To: Minister for the Environment (For Decision)

APPROVAL DECISION - GROUNDWATER DEPENDENT ECOSYSTEMS MANAGEMENT PLAN - EPBC 2010/5736 CARMICHAEL COAL MINE AND RAIL INFRASTRUCTURE PROJECT

2. Adani Mining Pty Ltd (the approval holder) has submitted for approval the *Groundwater Dependent Ecosystem Management Plan* (GDEMP), dated 19 March 2019, under the *Environment Protection and Biodiversity Conservation Act 1999* (EPBC Act) approval conditions 5 and 6 (**Attachment C**).

Figure 1. Spatial distribution of off-lease monitoring bores. Note that some locations represent nested bore sites. The green polygon shows the Proponent's mining lease areas.

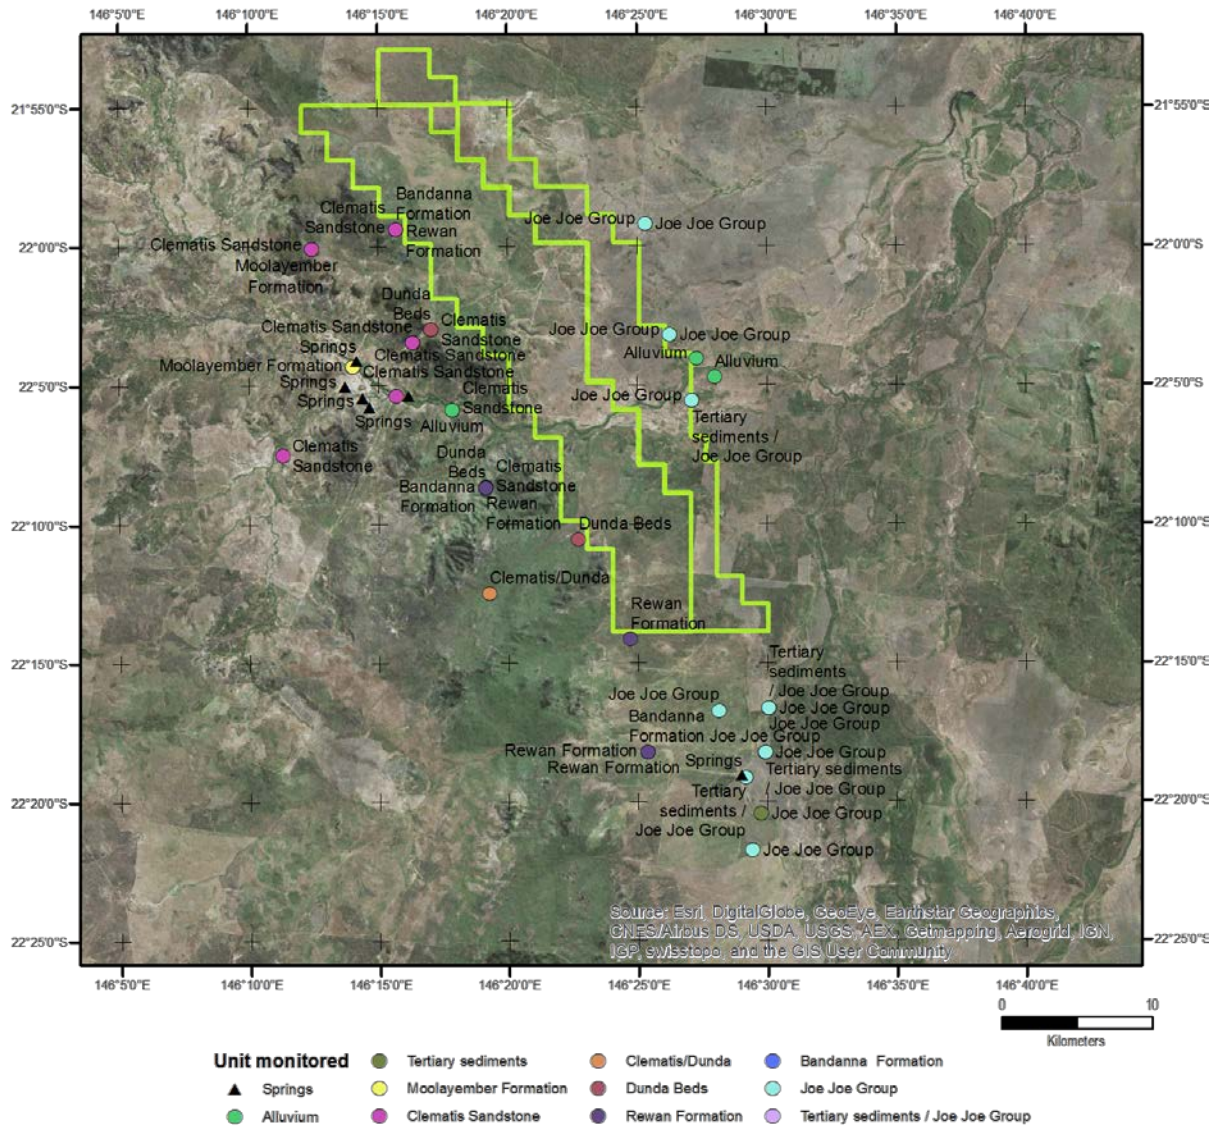
In the GMMP, there are 54 off-lease monitoring bores (Table 1 and Figure 1 below). The off-lease monitoring bores are primarily designed to monitor the Joe Joe Group and the Clematis Sandstone. These are the source aquifers proposed by the proponent for the Mellaluka Springs and DSC respectively. The monitoring network set out in the GMMP for the Mellaluka Springs appears adequate, given that these are sourced from the Joe Joe Group and Tertiary¹ sediments.
